Planning, Zoning, and Building Department

BOARD ACTION REPORT – APPEALABLE ITEM

Project Name: AutoNation Delray
Project Location: 1311 Linton Boulevard
Request: Class V Site Plan, Landscape Plan, and Architectural Elevations.

---STAFF REPORT---

L-3A

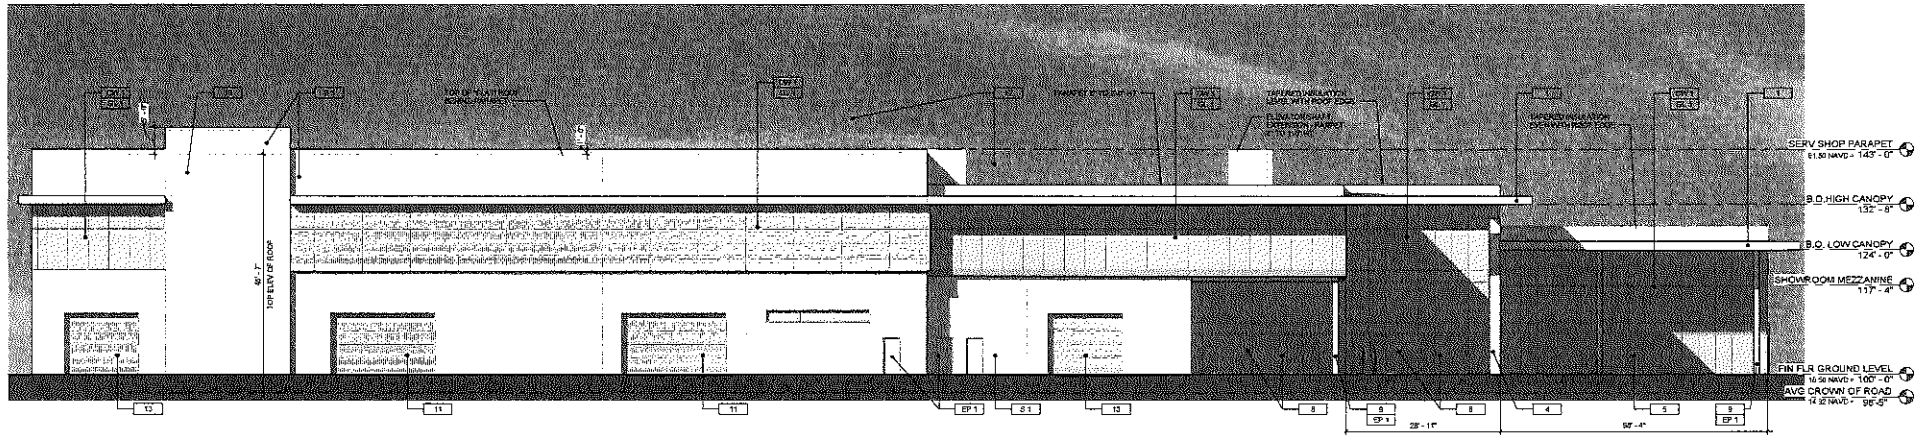
Per LDR Section 4.6.16(H)(3)(i), landscape islands which contain a minimum of 135 square feet of planting area, with a minimum dimension of 9 feet, exclusive of the required curb, shall be placed at intervals of no less than one landscaped island for every 13 standard parking spaces. One shade tree shall be planted in every island with a minimum of 75 square feet of shrubs and groundcovers. Tree specifications shall adhere to those listed in Section 4.6.16(E)(5) and 4.6.16(E)(6). Where approval for the use of compact parking has been approved, islands may be placed at intervals of no less than one 1 island for every 15 compact parking spaces. This landscape island is required for the display parking spaces along Linton Boulevard, where 27

and 14 parking spaces are provided in a row without the required landscape island. A condition of approval is attached that the plans be revised to provide the required interval of landscape islands and landscaping.

Move approval of the landscape plan for **AutoNation Delray Beach**, by adopting the findings of fact and law contained in the staff report, and finding that the request is consistent with Section 4.6.16 of the Land Development Regulations, subject to the condition that the plans be revised to provide the required interval of landscape islands and landscaping prior to certification of the site plan.
